The Edgewater Reconsidered
March 18, 2010

The Edgewater Reconsidered

The Edgewater as proposed has evolved well beyond a simple hotel addition to a complex that attempts to incorporate six independent profit centers, a 175 to 180-room luxury hotel, 9 to 14 semi-independent condominium residences, three (four include the dining pier) restaurants totaling 12,000 SF, a 12,000 SF meeting, banquet and convention facility, a 10,000 SF spa and fitness center and not less than 120 parking stalls for National Guardian Life

The Edgewater Reconsidered
 Lower Level 2 - Entry @ 1" = 30'
 March 18, 2010

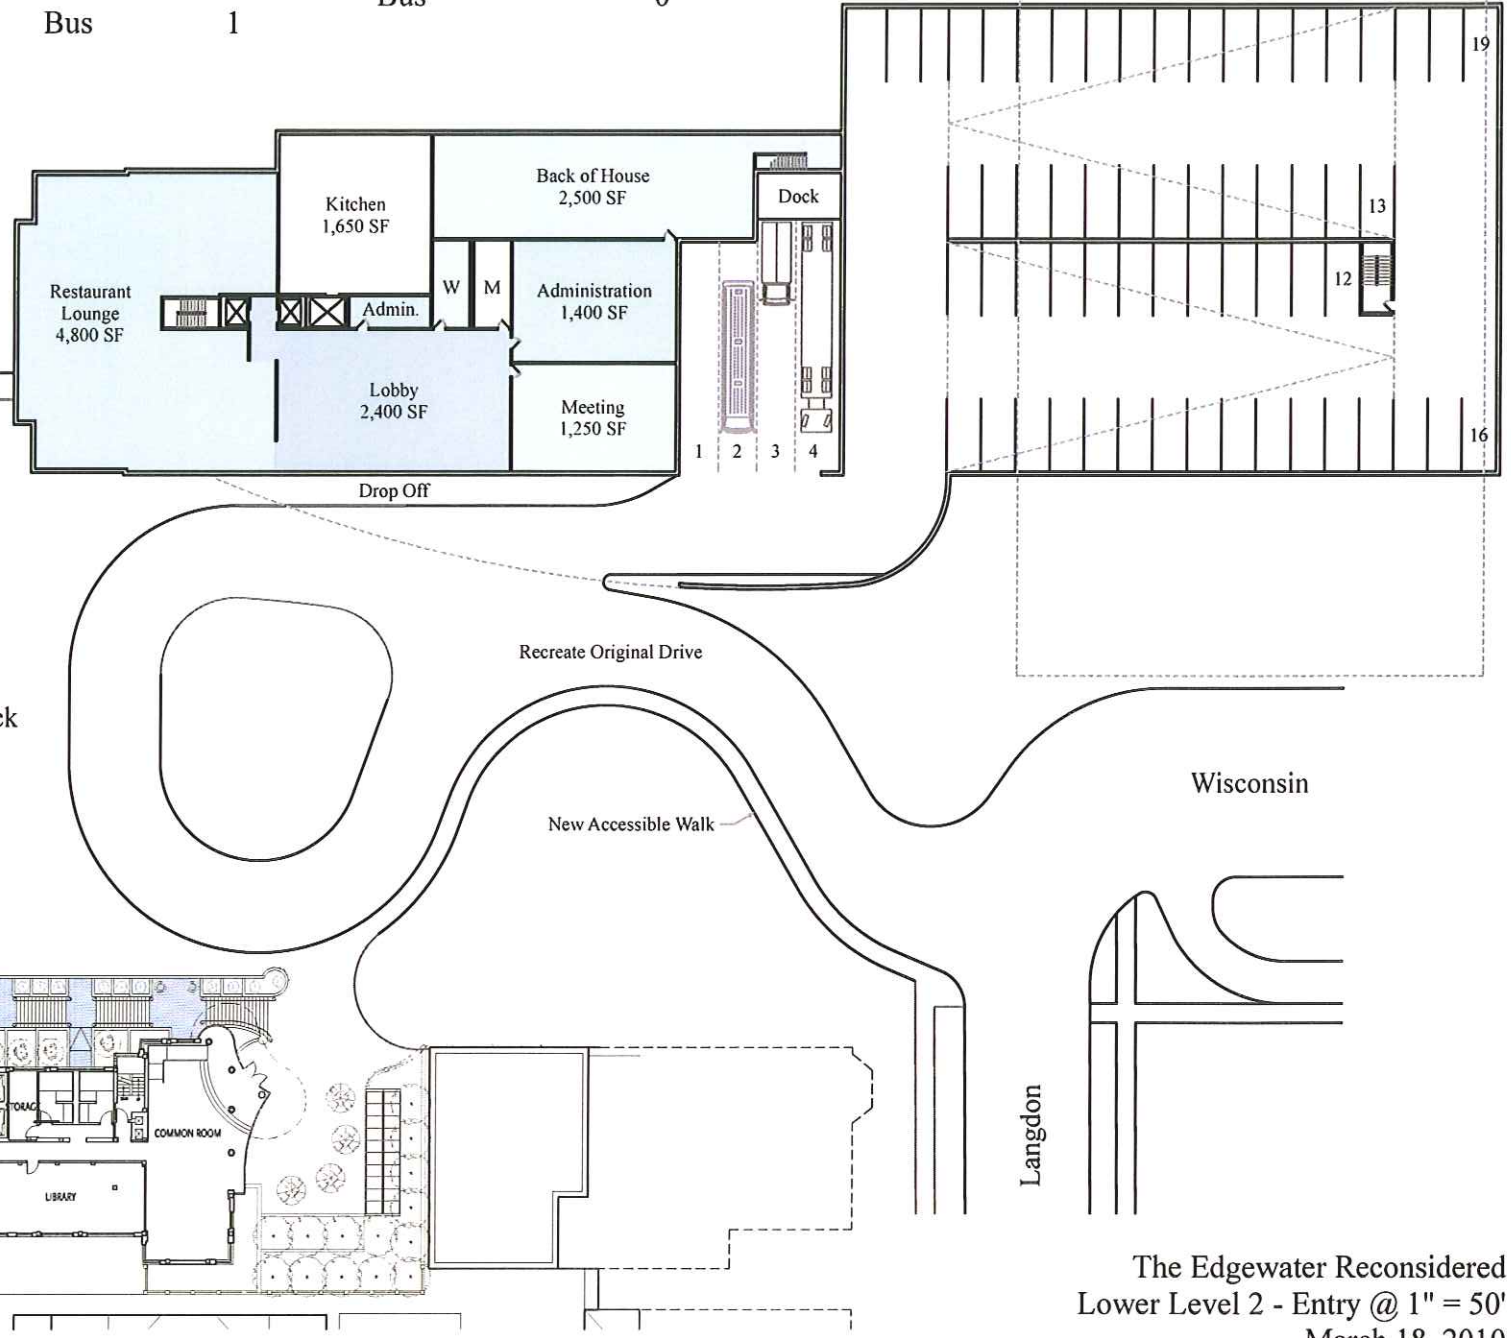
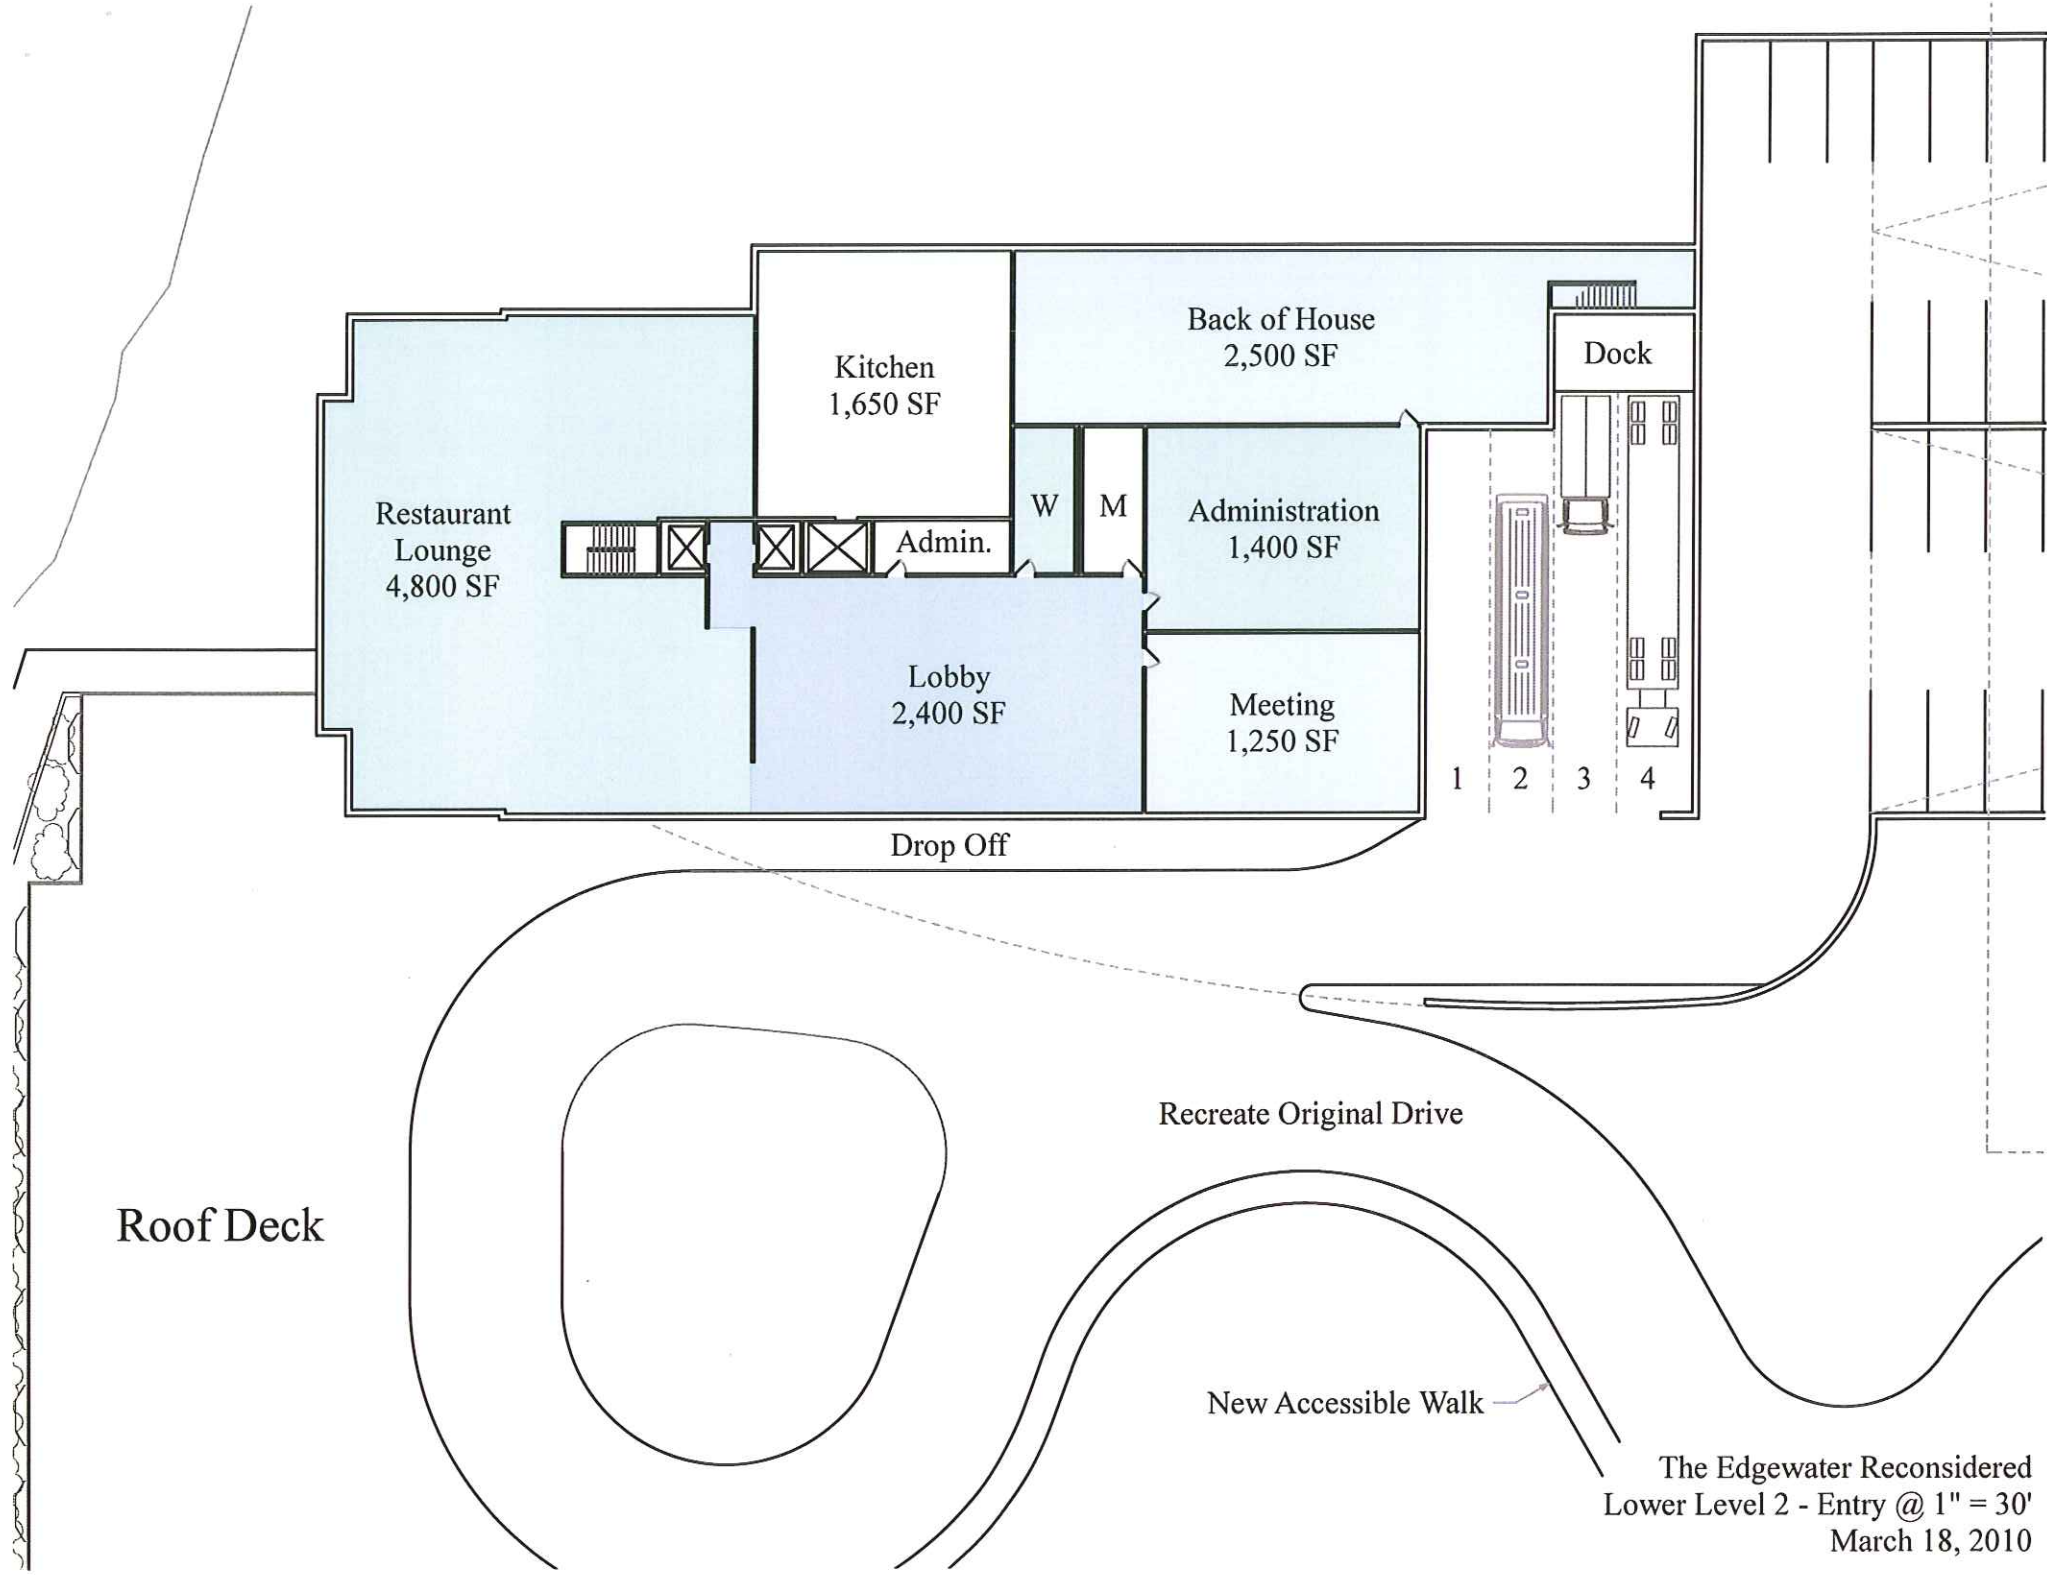
For instance the retaining wall built to support the hotel entry drive blocks the view of both the original

Edgewater and the proposed roof deck. The parking as proposed is located for the convenience of National Guardian Life employees forcing guests to traverse a long tunnel to access the hotel. The banquet /convention facility is given pride of place forcing the elevators well off center away from the lake essentially orphaning the guest rooms in the '47 and '72 buildings. The café is oriented away from both hotel and plaza on the corner of Langdon and Wisconsin ignoring both hotel guests and gathered public while creating an unwelcome commercial intrusion in the Mansion Hill neighborhood.

Original Drive

Loading Bus Berths:

As Reconsidered:

Semi-Trailer	1
Fixed Axel	1
Trash	1
Bus	1

As Proposed

Semi-Trailer	1
Fixed Axel & Trash	1 (Shared)
Bus	0

The Edgewater Reconsidered
 Typical Proposed & Reconsidered Floors Compared @ 1" = 25"
 March 18, 2010

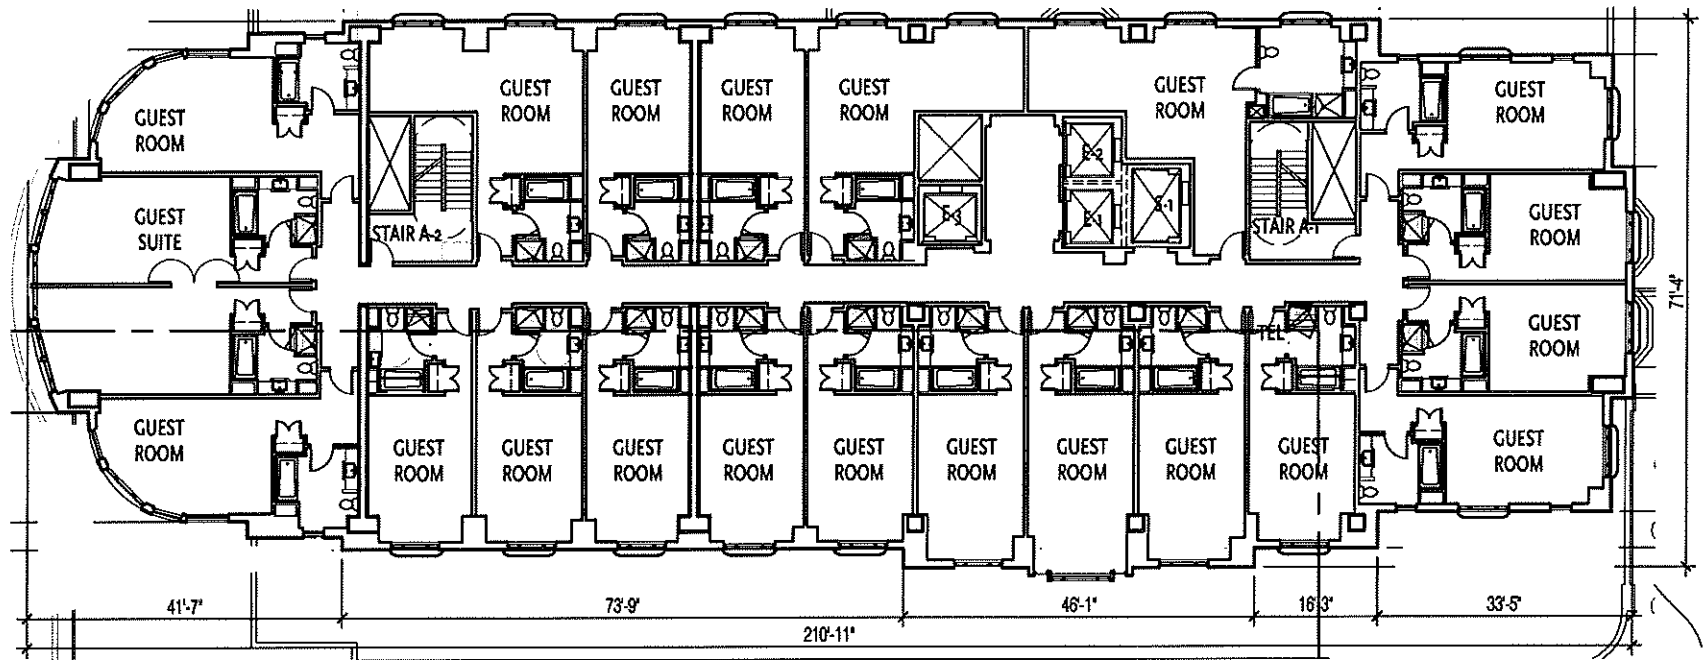
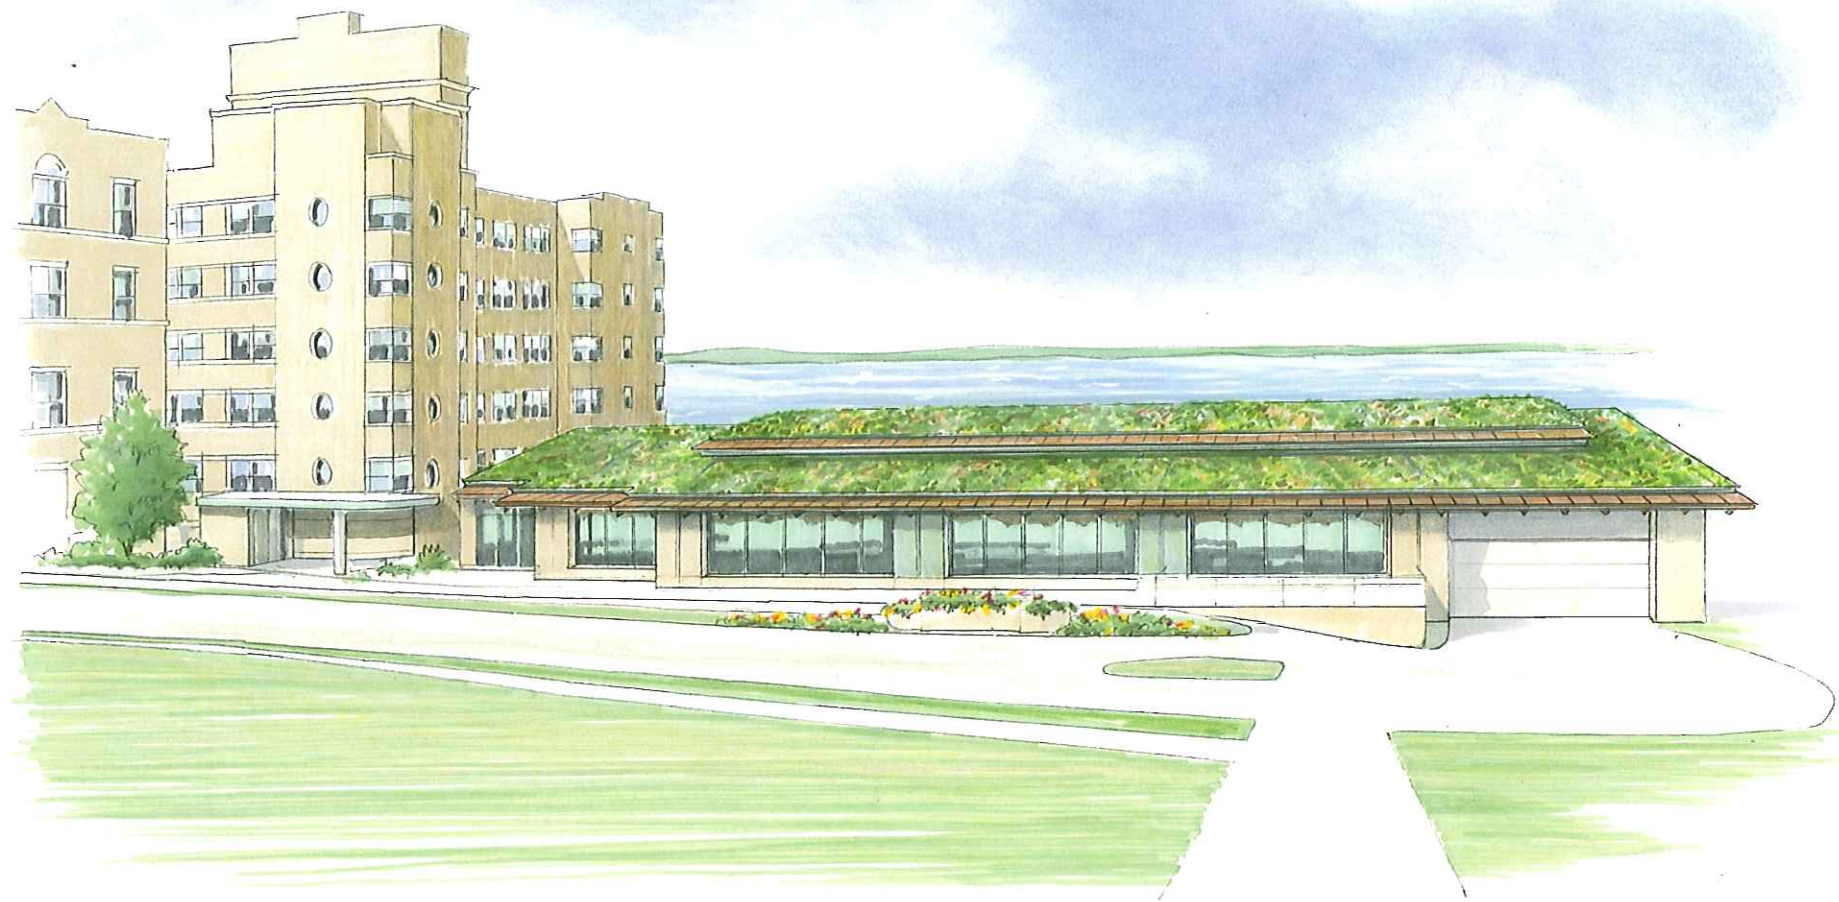
As Proposed 22 Keys, 13,715 GSF, 84.1% Efficient
 As Reconsidered: 32 Keys, 17,125 GSF, 86.6% Efficient (Housekeeping & Ice Missing)
